**PRELIMINARY OPINION of PROBABLE COST - DETAIL**  
**RENOVATE 200 MAIN STREET BUILDING**  
**WEST CHICAGO, ILLINOIS**  
**MATOCHA PROJECT NO.: 1506.01**  
**DATE: NOVEMBER 9, 2015**

December 29, 2015

Re: 200 W. Main Street  
West Chicago, Illinois

EXISTING SECOND FLOOR FRAMING PLAN

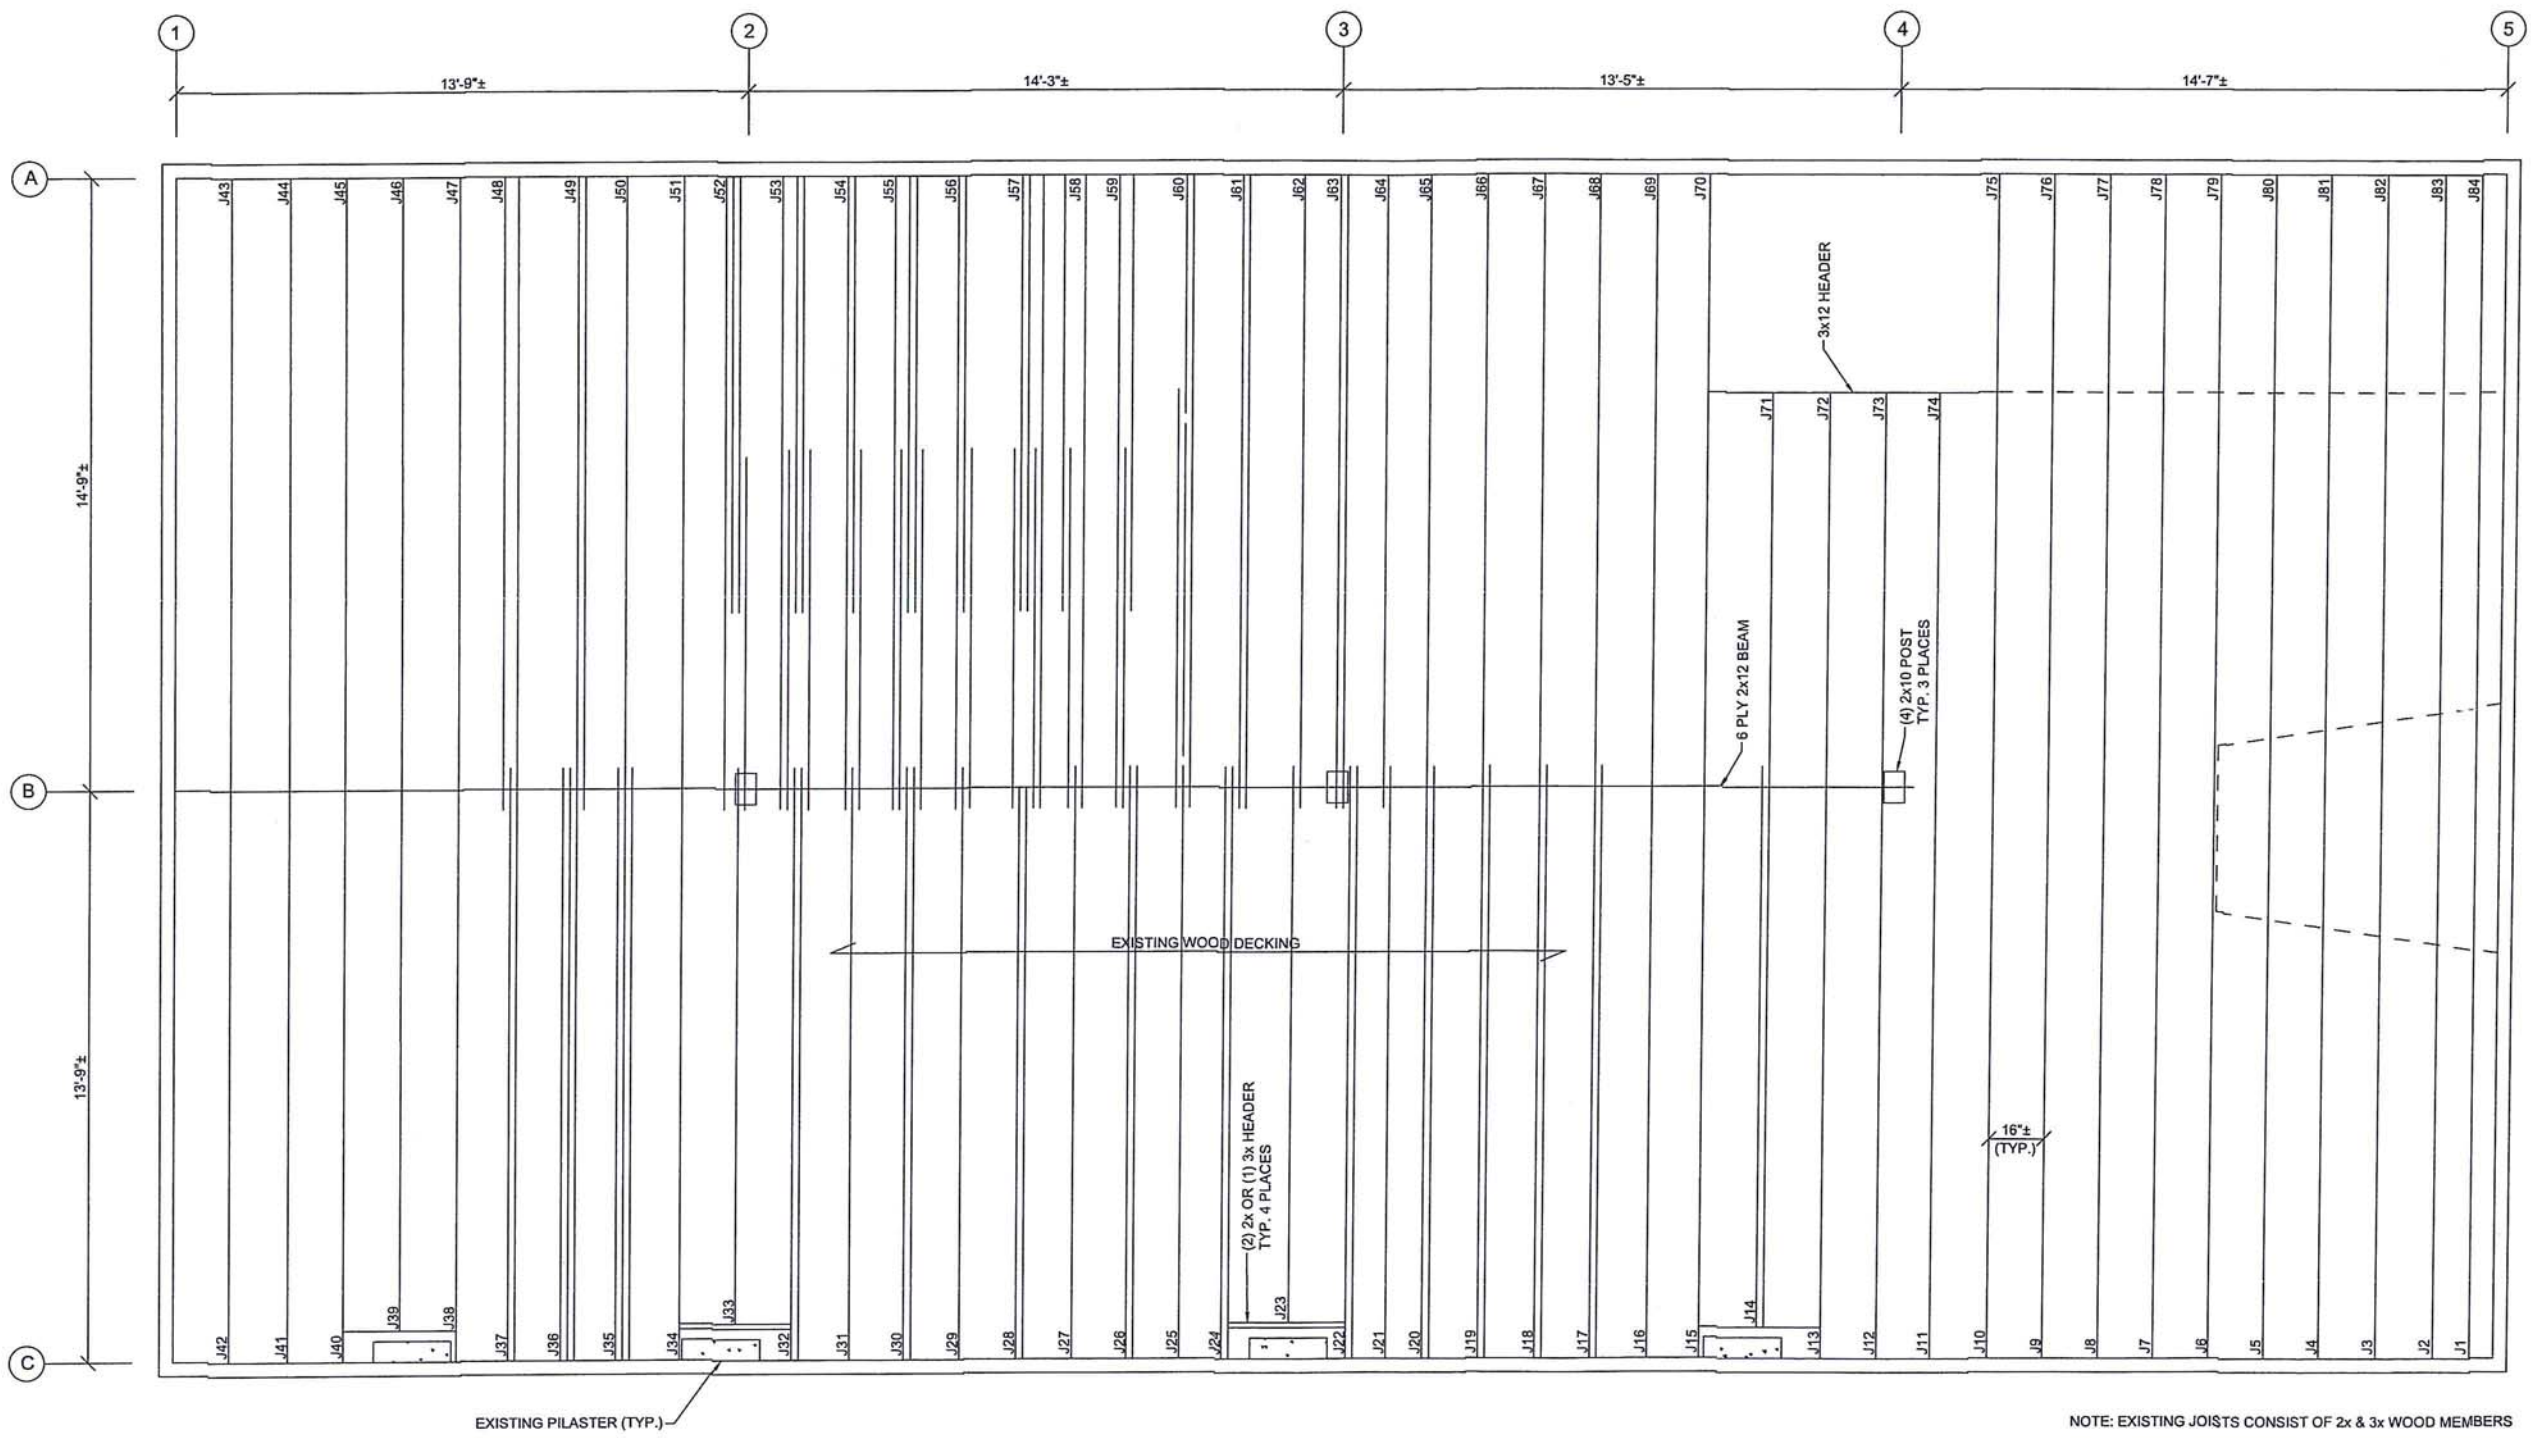
1. A number of the original 3x12 floor joists have failed.
2. A number of the original 3x12 and 2x12 floor joists have been compromised by post installed notches and holes.
3. The floor joists in the central area of the west half of the floor plate were pieced together with partial span members. We highly doubt that the existing splices are adequate to develop the required shear and moment.
4. The post installed 6 ply 2x12 beam spanning in the north-south direction at approximately the middle of the building in the east-west direction is not adequate to support the required dead and live loads.

5. The existing 3x12 joist members in the front of the building spanning from exterior wall to exterior wall are not adequate to support the required dead and live loads.
6. The existing joist sections towards the back of the building on the east side of the 6 ply 2x12 beam line support the load bearing wall on the second floor. These joists are not adequate to support the required dead and live loads.

Please reference the attached drawings for review which is our representation of the scope of work required to address the issues noted above. If you should have any questions or would like to discuss any of these issues further please do not hesitate to call.

**Image 2**

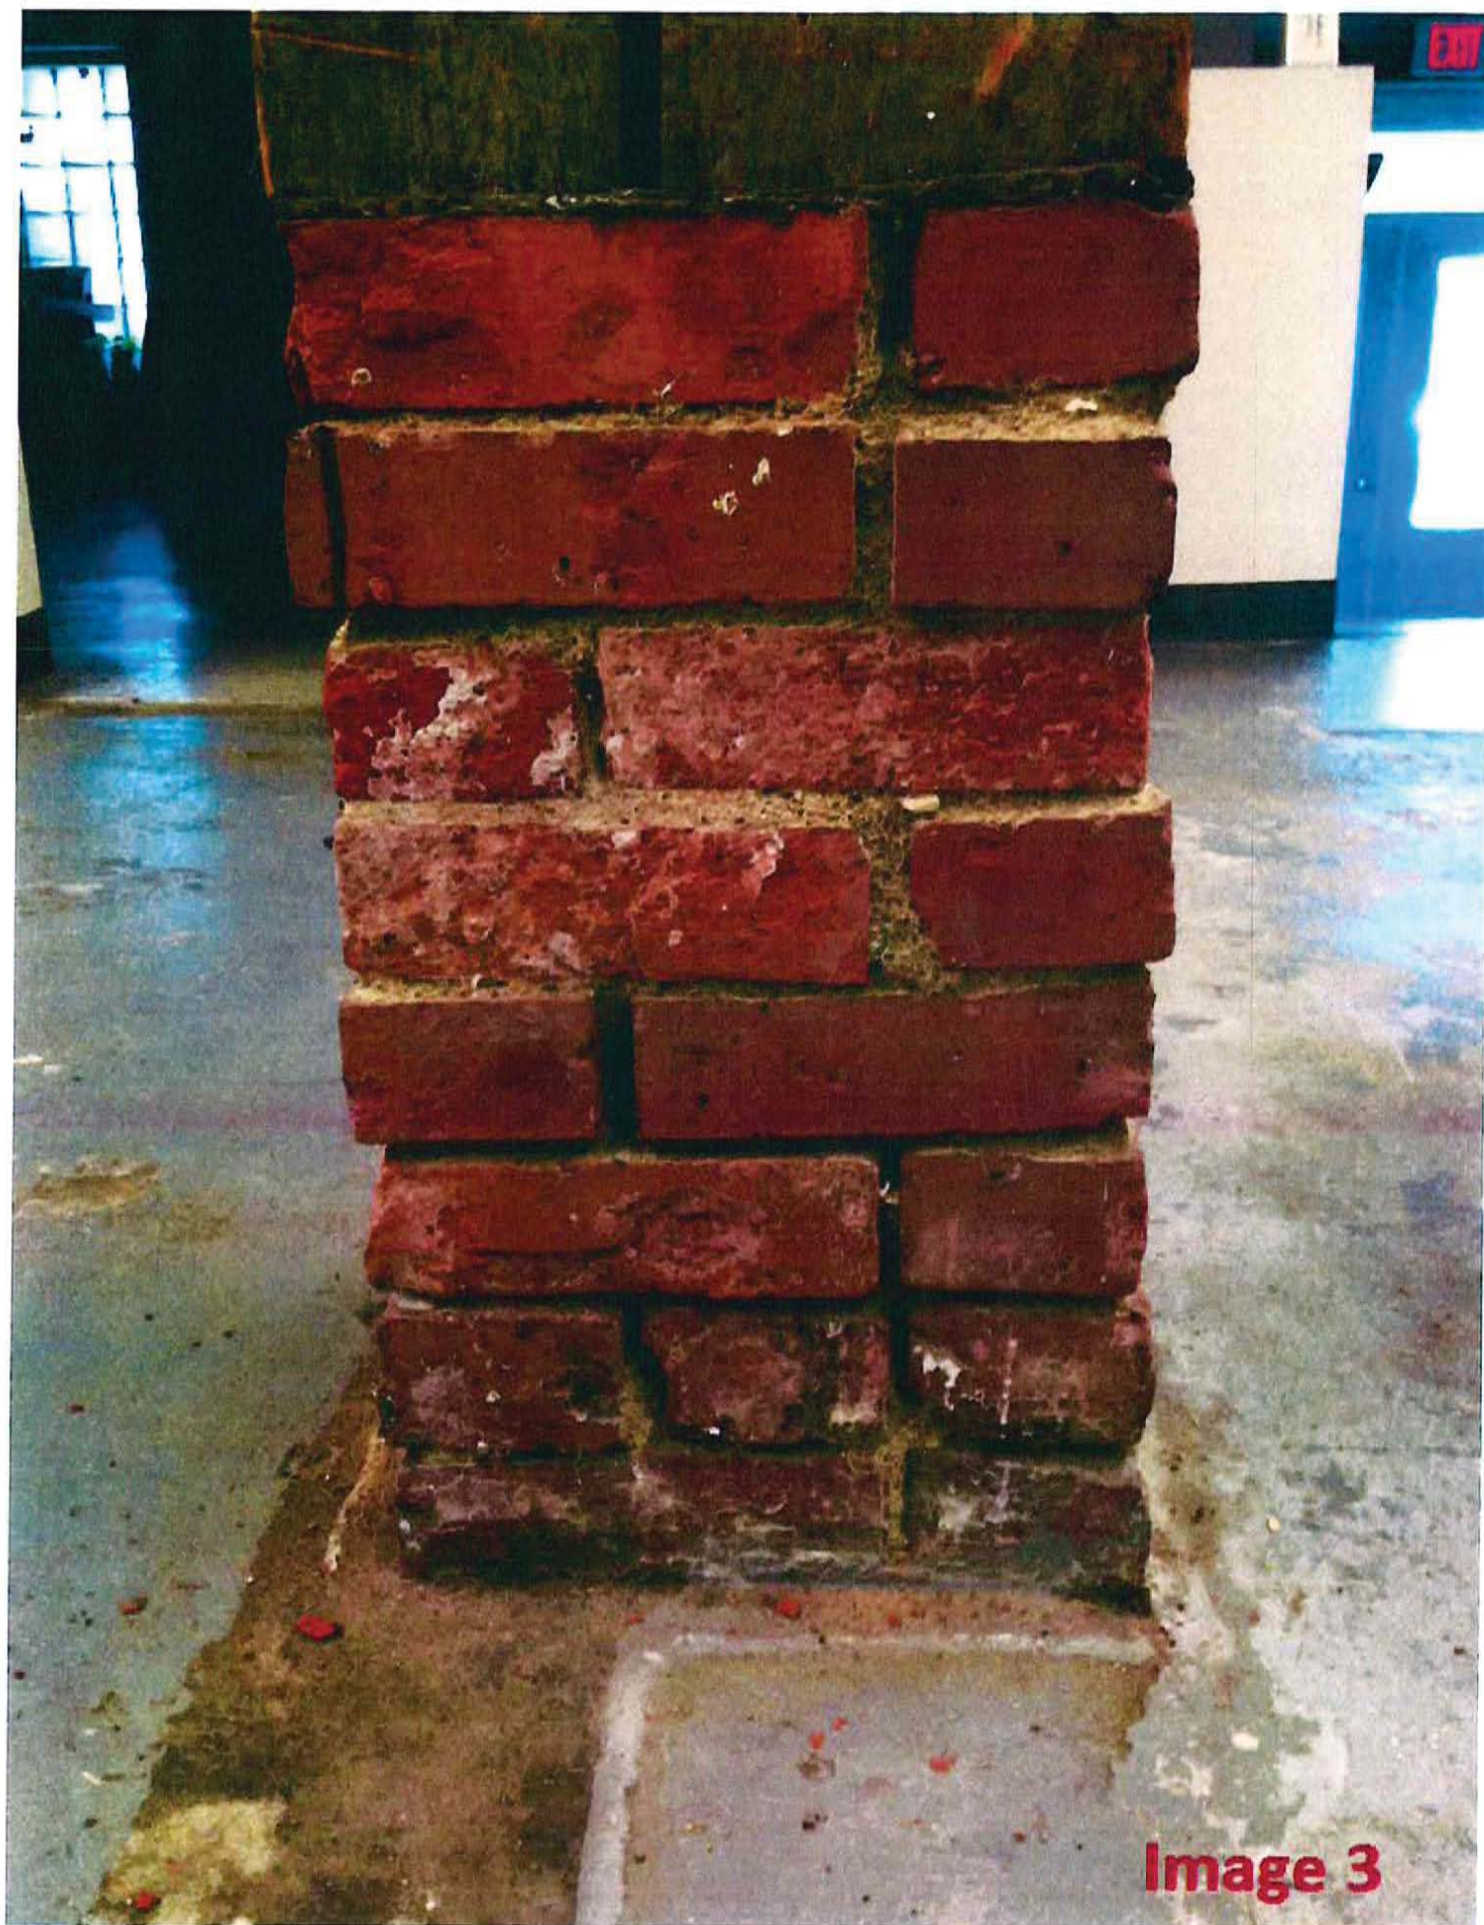
- The foundation walls consist primarily of sandstone which appeared to be in generally good condition. Calcium deposits were noted predominantly on the north wall (Image 1) suggesting that moisture has been/is penetrating the foundation wall. A collection of dissolved sandstone/mortar was noted at the base of the wall most notably along the north wall (Image 2) suggesting that some degree of deterioration of the wall has occurred.

**Image 3**

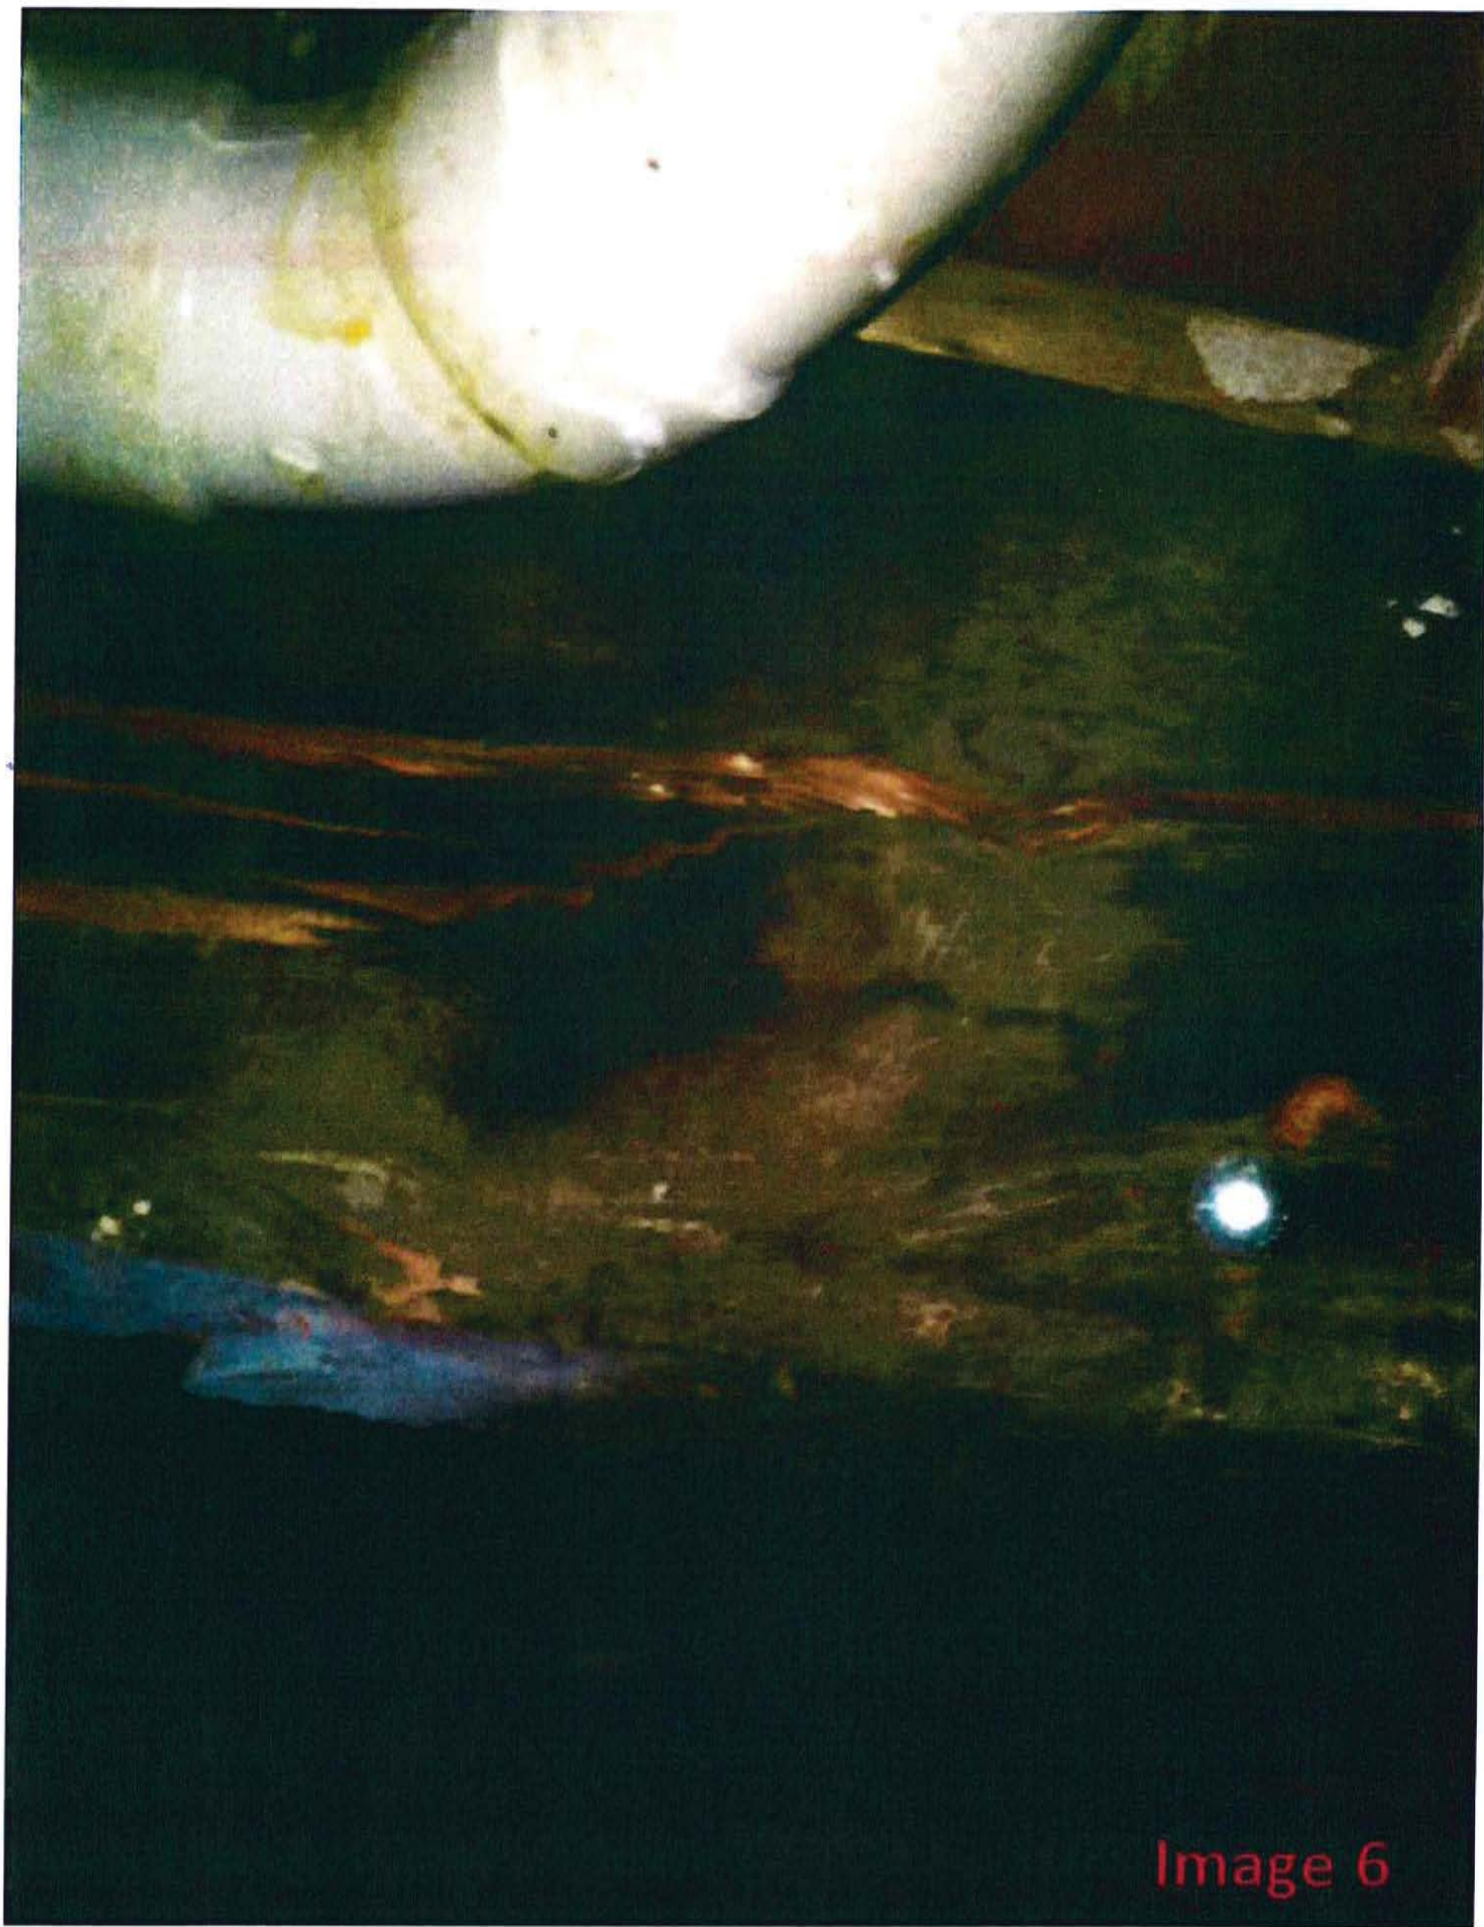
- Some minor tuckpointing of the foundation walls and the center support column brick base should be considered (Image 3).
- There is a crack in the southeast corner of the foundation wall that could be filled with an epoxy injection product but we would not consider this to be entirely necessary (Image 4).
